DOE/NV--1312-Rev. 2

Phase II Corrective Action Investigation Plan for Corrective Action Units 101 and 102: Central and Western Pahute Mesa, Nevada Test Site, Nye County, Nevada

Nevada Division of Environmental Protection Comments

NEVADA ENVIRONMENTAL RESTORATION PROJECT DOCUMENT REVIEW SHEET

Plate 1
Pahute Mesa
Well Location Map
Showing Proposed Phase II
Well Locations and Priority

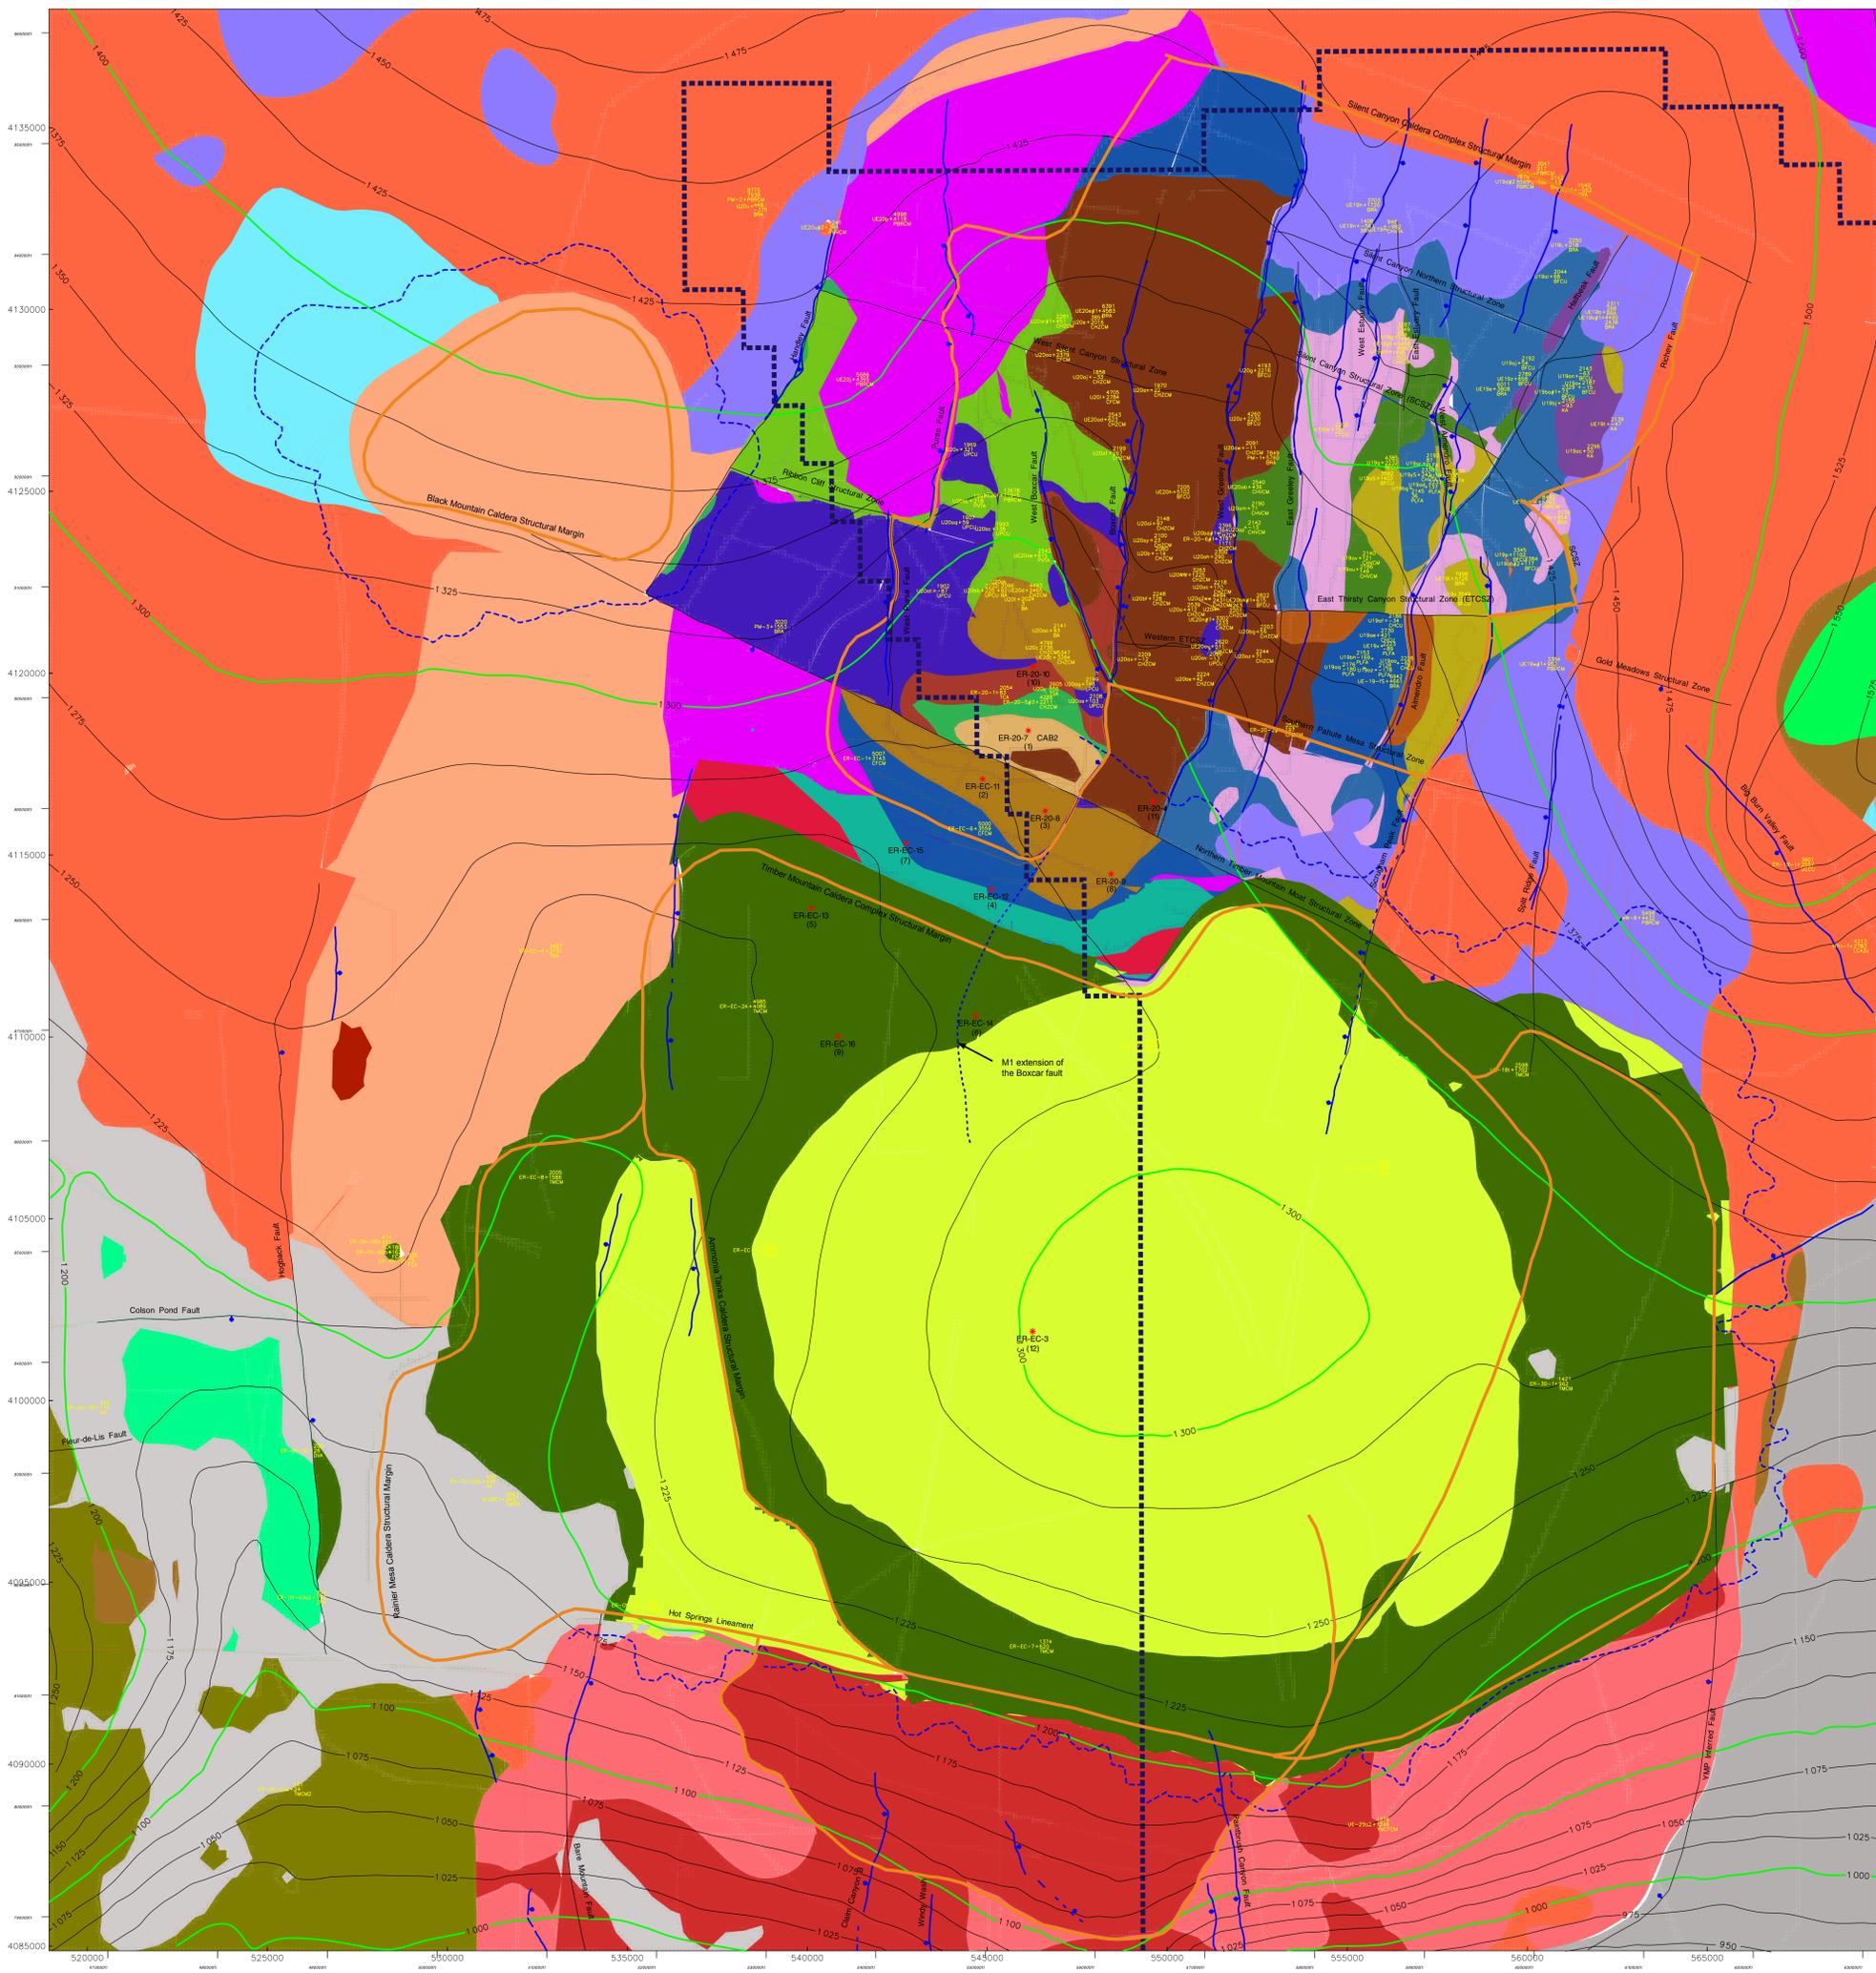
25. P. 88, Figure 6-1	M	Kind of hard to read.	The figure conveys much information, and has been made as clear as possible. Please refer to Plate 1 for additional detail.	Accept, see comment response
		<p><u>“FFACO-related” and Consistency Comments:</u></p> <p>The following comments have been generated while reviewing the document (1) in light of the NNSA/NSO and the NDEP’s verbally agreed-to changes to the FFACO and (2) for consistency throughout the document. The FFACO changes are currently being documented in writing through a modification to Appendix VI of the FFACO. The needed changes include, but are not necessarily limited to,:</p>
